MEETING NOTES

Meeting Date : April 15, 2009 Project : UO Lewis Integrative Science Building
Author : Regina Filipowicz Job No. : THA Project 0810
Re : Imaging Lab User Group SD Meeting 1

Figure 1

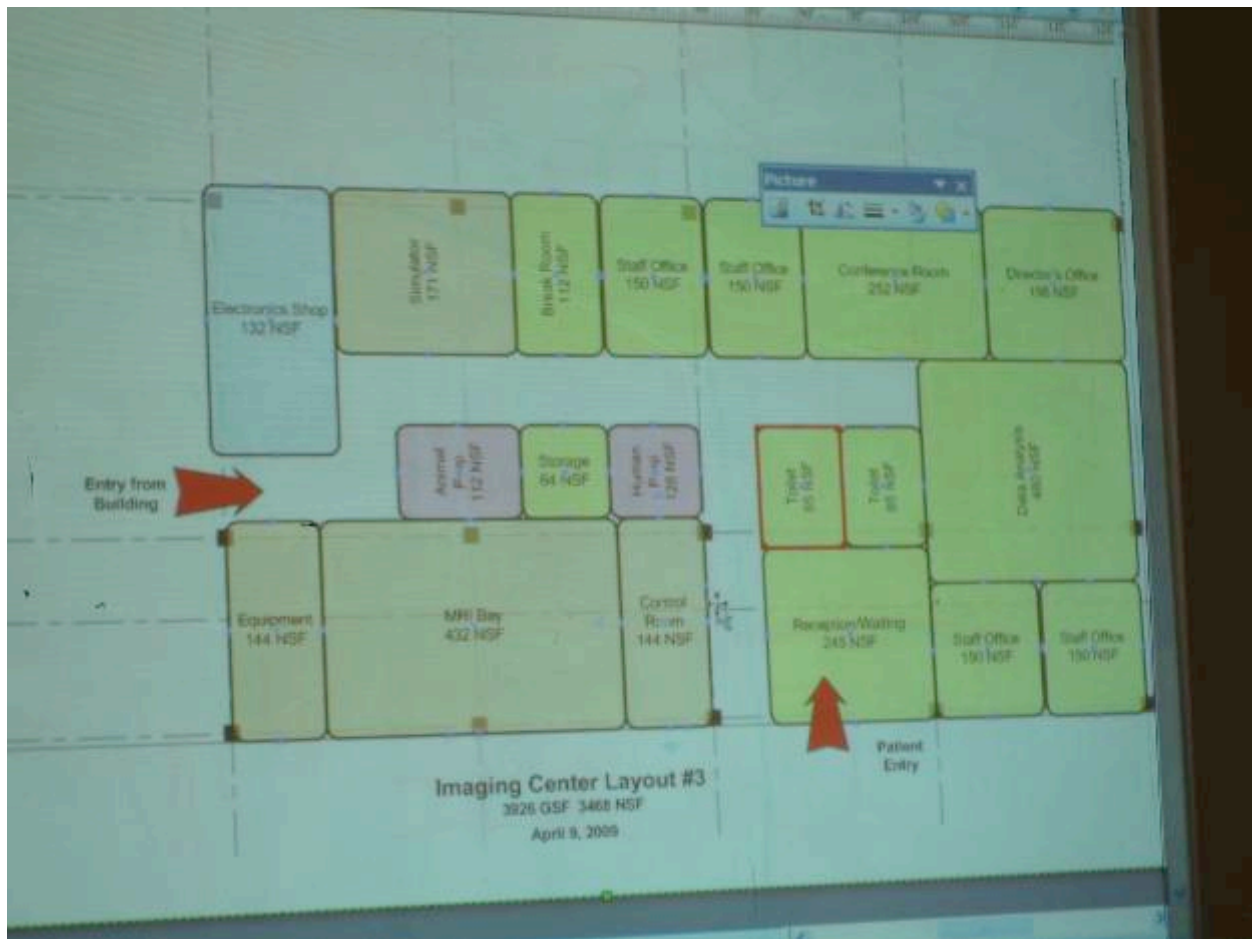
1. Chuck walked through the current designs with the Users discussing pro and cons of each.
2. Imaging Center layout No. 3 seemed to be the preferred layout – *refer to Figure 1*
3. Human Prep space is primarily a paperwork space and can be smaller, roughly 64 sf
4. Jolinda indicated the Electronics Shop is much too small and needs to be larger, *refer to Figure 1.*
5. MRI Equipment Room requires a direct door from the exterior for equipment and LHe deliveries.
6. Chuck pointed out there should be a removable panel at the south wall of the MRI Bay for the inevitability of repairing and/or replacing the magnet.
7. Scott mentioned that it's critical we bring a third party shielding consultant on board, preferably one with MRI focused consulting.
